UNITED STATES PATENT AND TRADEMARK OFFICE

Office Action Summary	Application No. 10/807,420	Applicant(s) BARRILE-JOSEPHSON ET AL.	
	Examiner MICHAEL G. MENDOZA	Art Unit 3734

DETAILED ACTION

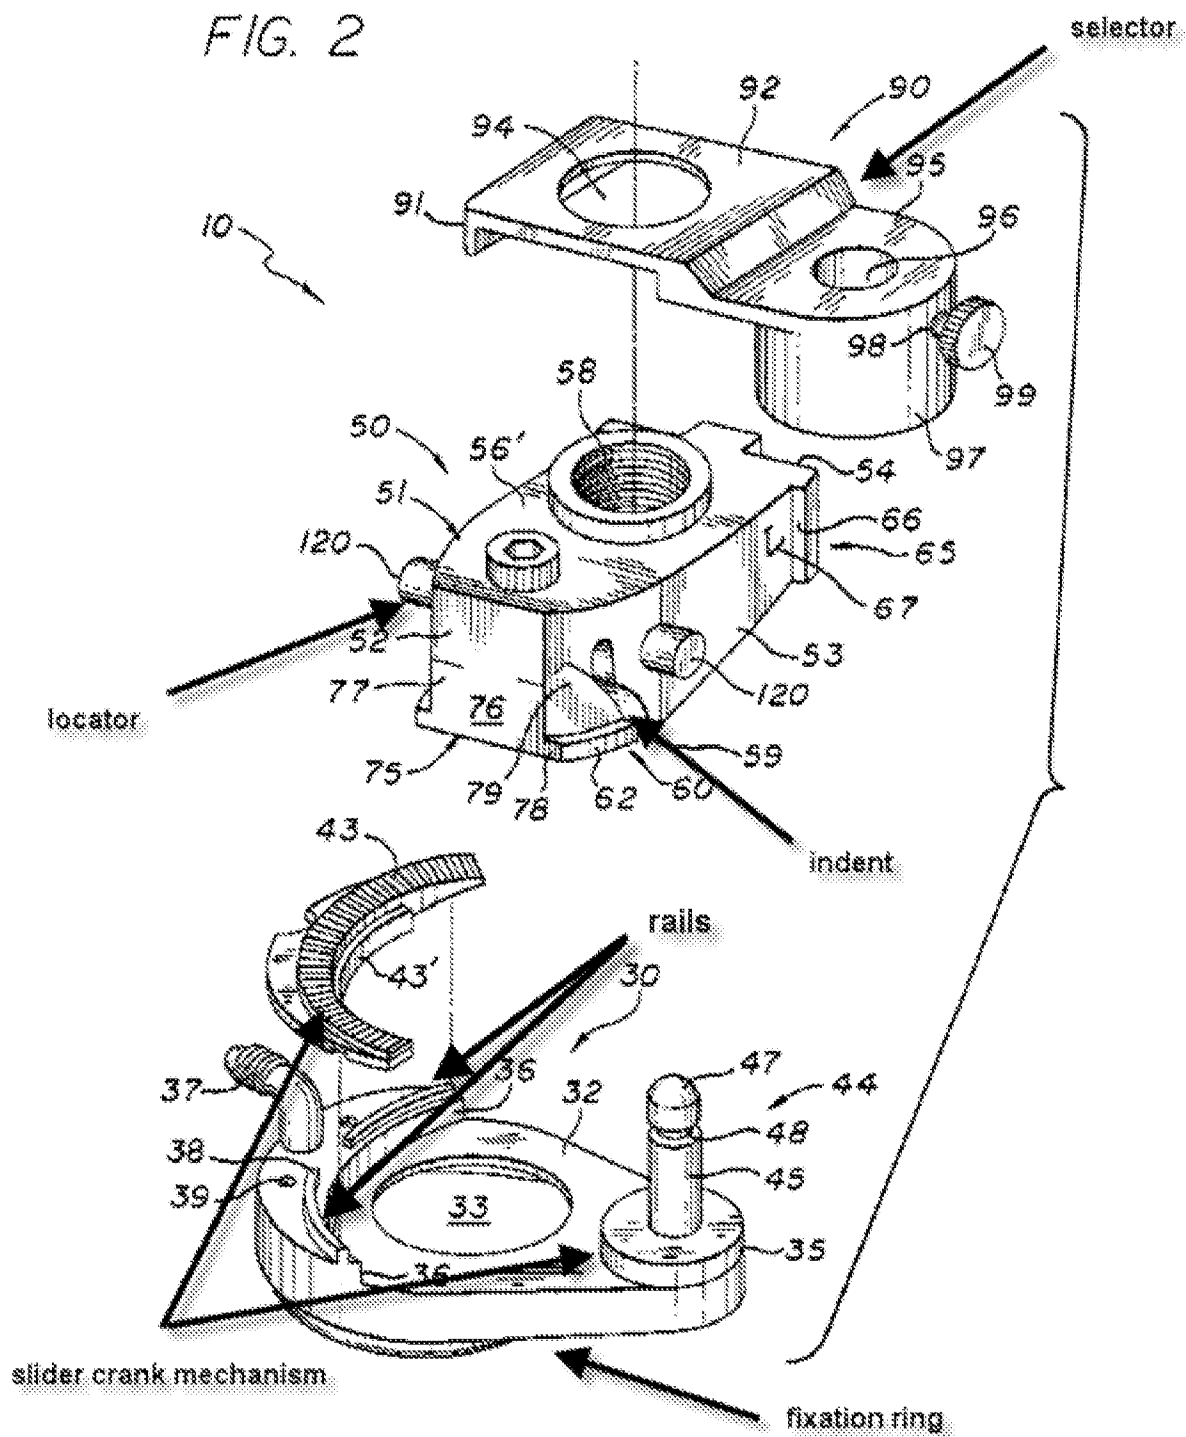
6. Amano et al. teaches a microkeratome for use in ophthalmic surgery comprising: a slider-crank mechanism; a cutting-head; a fixation ring; wherein the slider-crank mechanism moves the cutting-head at least partially across the fixation ring; a controller (61); wherein the drive includes a left/right selector that is alternately moveable between a start position of the drive for a patient's left eye and a start position for a patient's right eye (col. 6, lines 13-17); resilient spring-like arms (62); a cutting-head locator; a translation stop (50); a motor (21); a passage from a bottom surface of the ring and with the ring for connection to a vacuum source (61); wherein the fixation ring includes structure extending beyond a bottom-most part of an annular ring and raised about the bottom-most part of the annular ring (see fig. 1b).

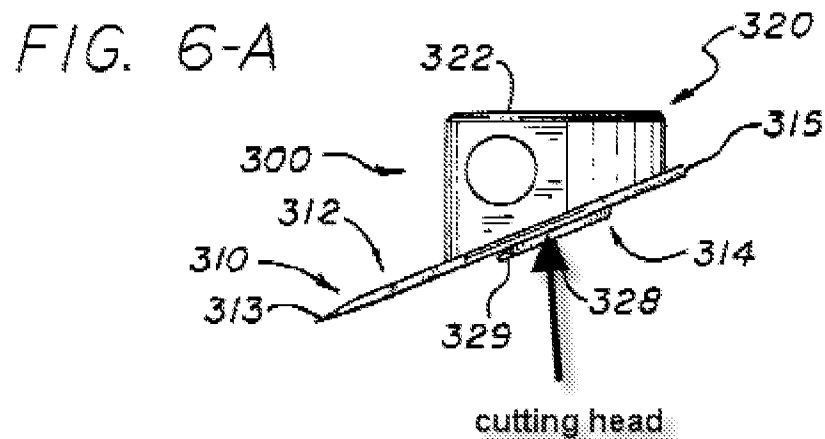
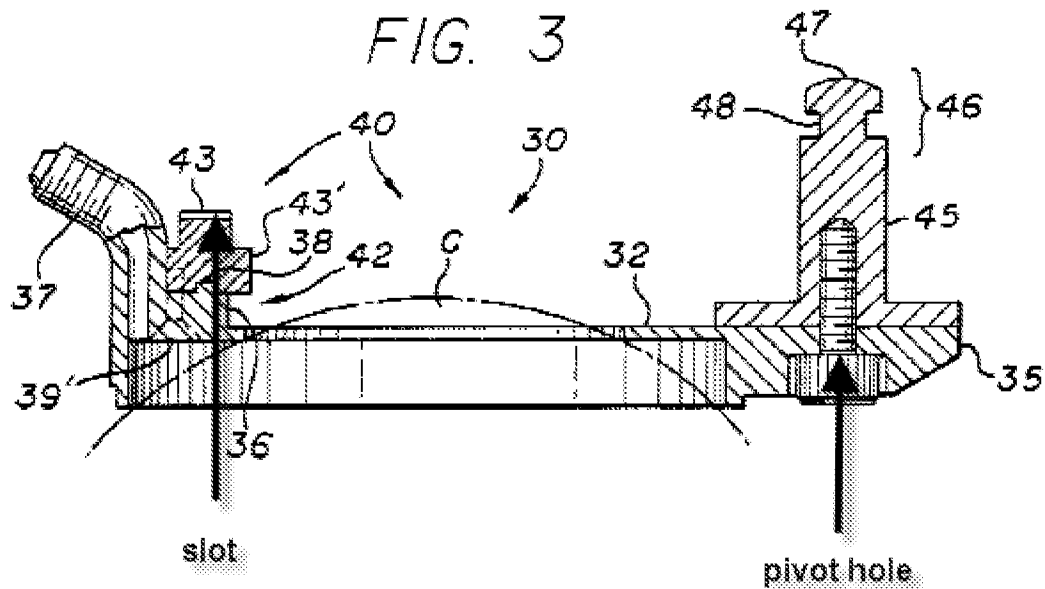
8. Hellenkamp et al. teaches a microkeratome for use in ophthalmic surgery comprising: a slider-crank mechanism (motor cranks gears to slide blade); a cutting-head; a fixation ring; wherein the slider-crank mechanism moves the cutting-head at least partially across the fixation ring; a controller (200); wherein the drive includes a left/right selector that is alternately moveable between a start position of the drive for a patient's left eye and a start position for a patient's right eye (see figs. 10a-10b); a cutting-head locator including indents; a translation stop (65); a motor (100); a passage from a bottom surface of the ring and with the ring for connection to a vacuum source (col. 7, lines 1-18); wherein the fixation ring includes structure extending beyond a bottom-most part of an annular ring and raised about the bottom-most part of the

annular ring (see figs. 3-5); wherein the slider-crank mechanism includes a pivot hole and a slot formed on the fixation ring (between each tooth of track 43 there is a slot); wherein the pivot hole and the slot are generally on opposite sides of the ring; wherein the pivot hole and the slot cause the cutting head to move in an arcuate path (see figs. 10a-10b); wherein the slider-crank mechanism includes at least two slot formed on the fixation ring and a pair of rails.
